DEVELOPMENT REVIEW COMMITTEE (DRC) COMMENT REPORT

PROJECT NAME: Suncrest Court – Block 2

CASE NUMBER: R18027

REQUEST: Site Plan Level II Review: 56 Multifamily Residential Units

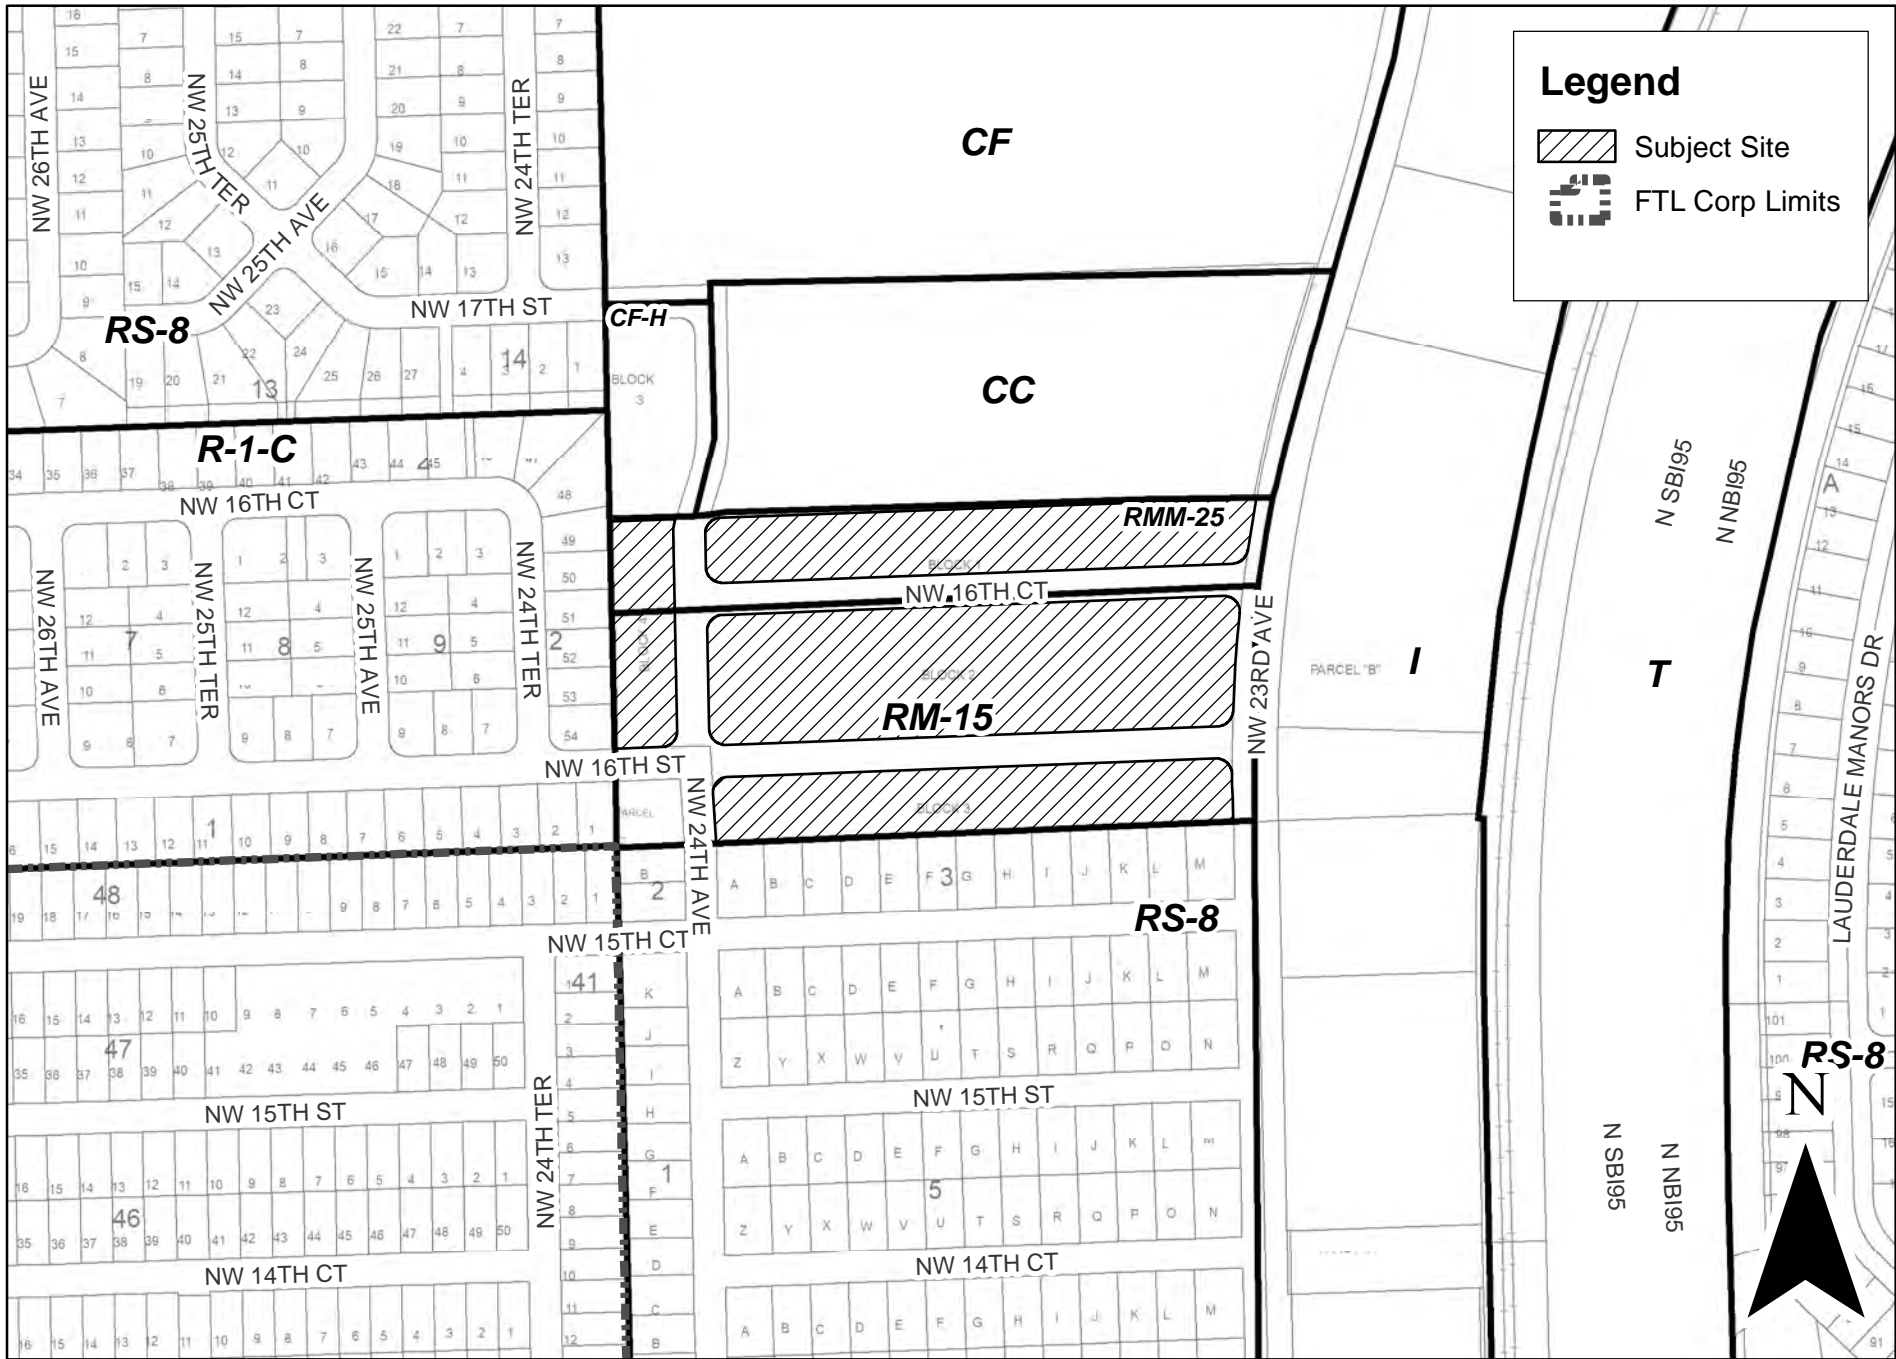
14. The City owns and maintains stormwater infrastructure adjacent to the proposed development as shown with green line work in the map provided at the end of this report. The following comments pertain to possible impacts of the proposed development and/or construction activities to the existing condition of the City's stormwater assets. The applicant shall provide an itemized response letter addressing the following comments:

- a. Please note that no private stormwater infrastructure (drainage pipes, wells, or basins,) can be constructed in City Right of Way or in City drainage easements. Please remove any proposed stormwater systems that are not in compliance with this requirement or provide appropriate documentation of City Rights-of-Way or easement vacated to allow the construction of private underground utilities.

- b. If the development is proposing to remove street swales and construct parallel parking and concrete curbing as shown on the overall site layout, the Civil engineer shall address the City street flood protection criteria & maintenance of City's stormwater assets. Please coordinate requirements with Engineering.
- c. If dewatering activities are anticipated, a notarized City dewatering affidavit shall be filed at City's building department when submitting a demolition or foundation permit along with any applicable dewatering permit form regulatory agencies such as the South Florida Water Management District or Broward County Department of Environmental Protection.
- d. **Existing Stormwater Asset Map possibly affected by the Proposed Development:**
